# Permit Application Review

Permit #2022-071 and #2022-072  
Received complete: August 31, 2022

Applicant: Todd Simning; Old Vernon Development, LLC.  
Consultant: Josh Rinke; Advance Surveying & Engineering Co.  
Project: Lots 2-6, Block 6: Olde Vernon 3<sup>rd</sup> Addition  
Location: 5829 Vernon Lane, Edina, MN  
Applicable Rule(s): 4, 5, 11 and 12  
Reviewer(s): Louise Heffernan and Bob Obermeyer; Barr Engineering Co.

Figure 2. Stormwater Management Facility Locations

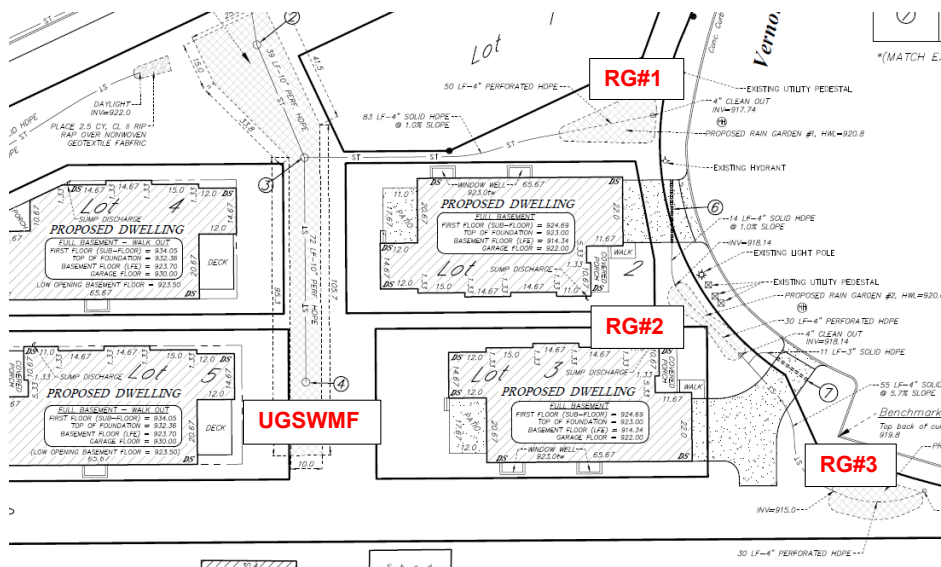
Stormwater management for compliance with subsection 4.3.1 will be provided by four best management practices (BMP's), including one underground stormwater management facility (UGSWMF) infiltration trench, and three rain gardens to provide rate control, volume retention and water quality management for the site. The BMP locations, relative to the lots, are shown on Figure 2 below.

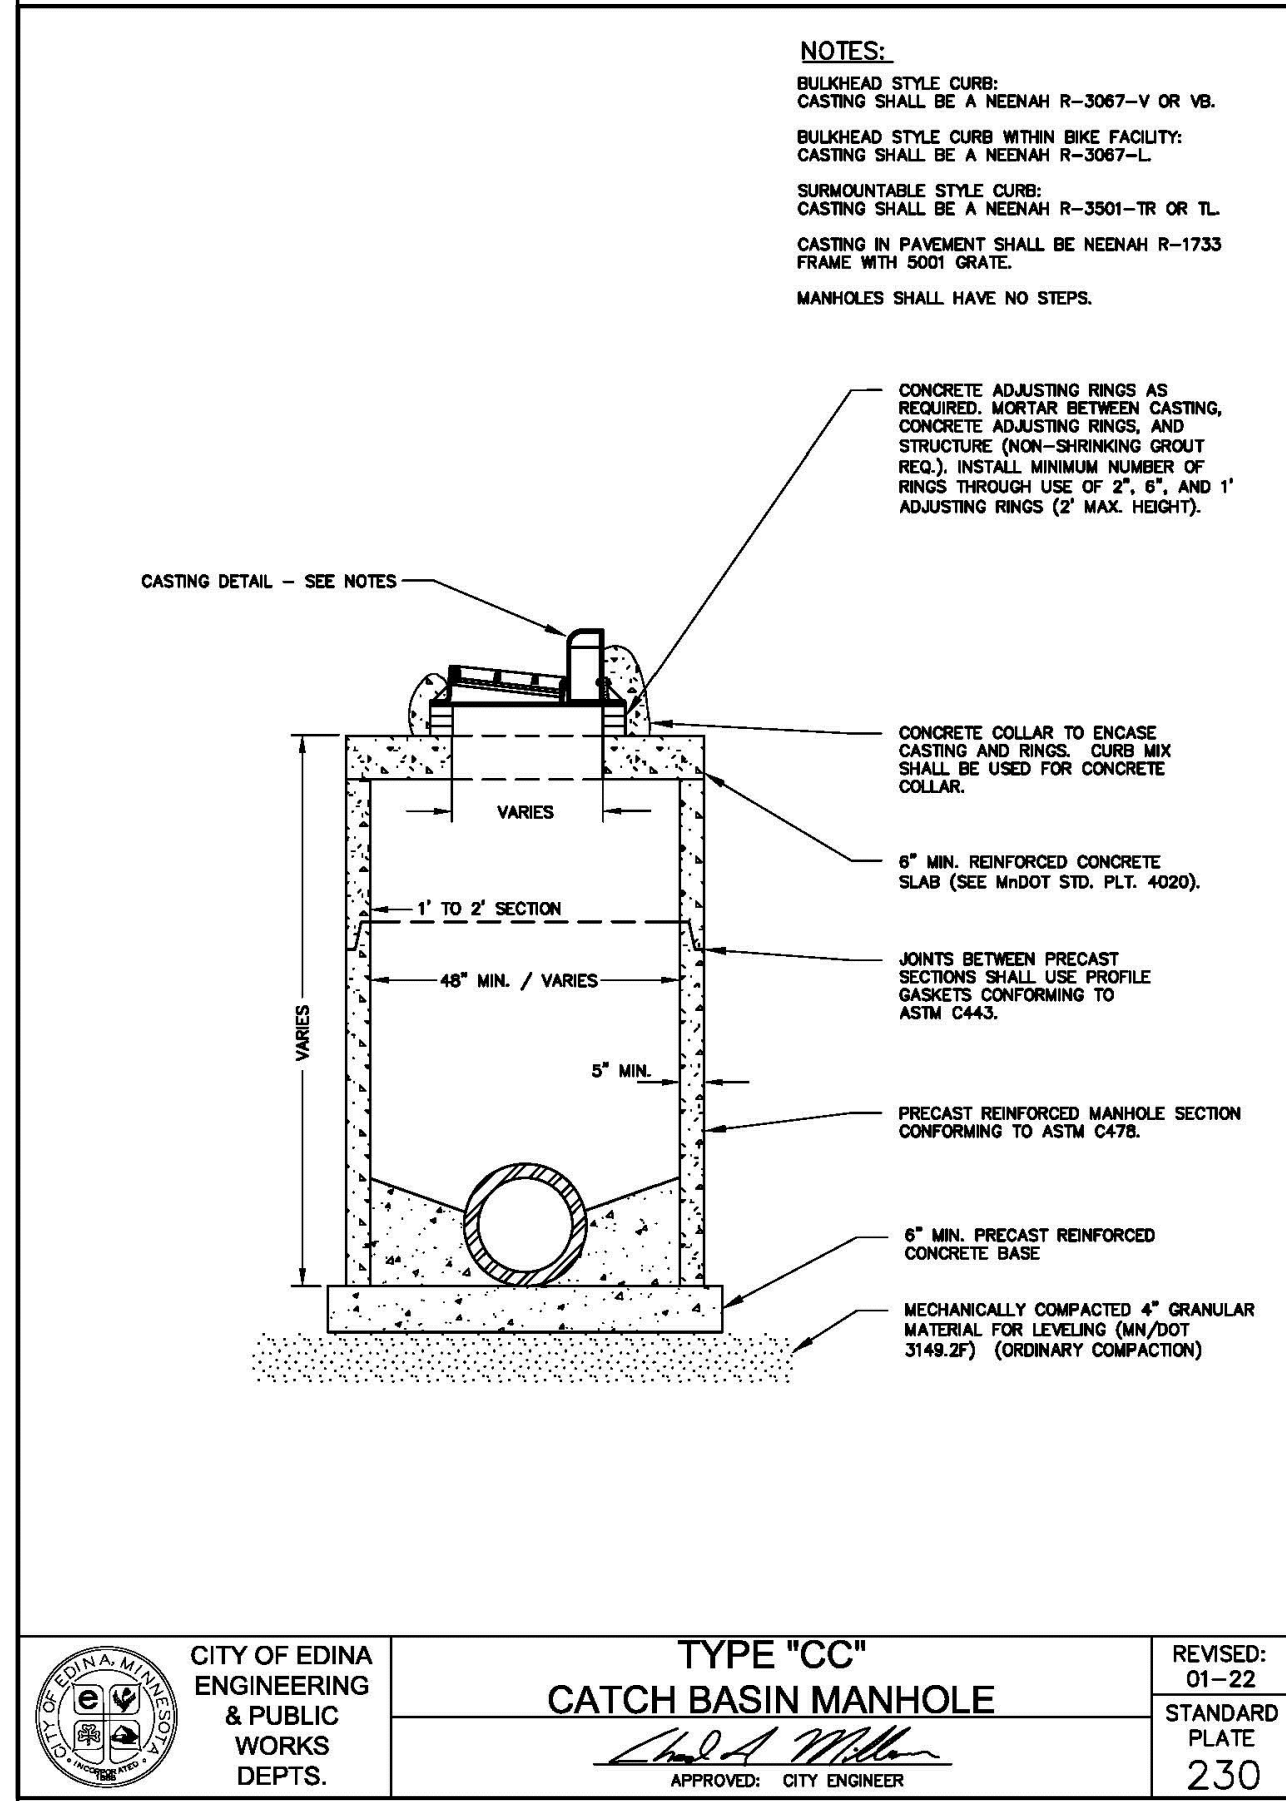
\*The plans indicate a retaining wall will be installed between Rain Garden #1 and the low opening garage entrance to provide at least two feet of separation. Additionally, the emergency overflow will direct Rain Garden #1 overflow to Vernon Lane. The top of the retaining wall is elevation 923.0 M.S.L., providing a separation of 2.2 feet, in compliance with subsection 4.3.3 criteria.
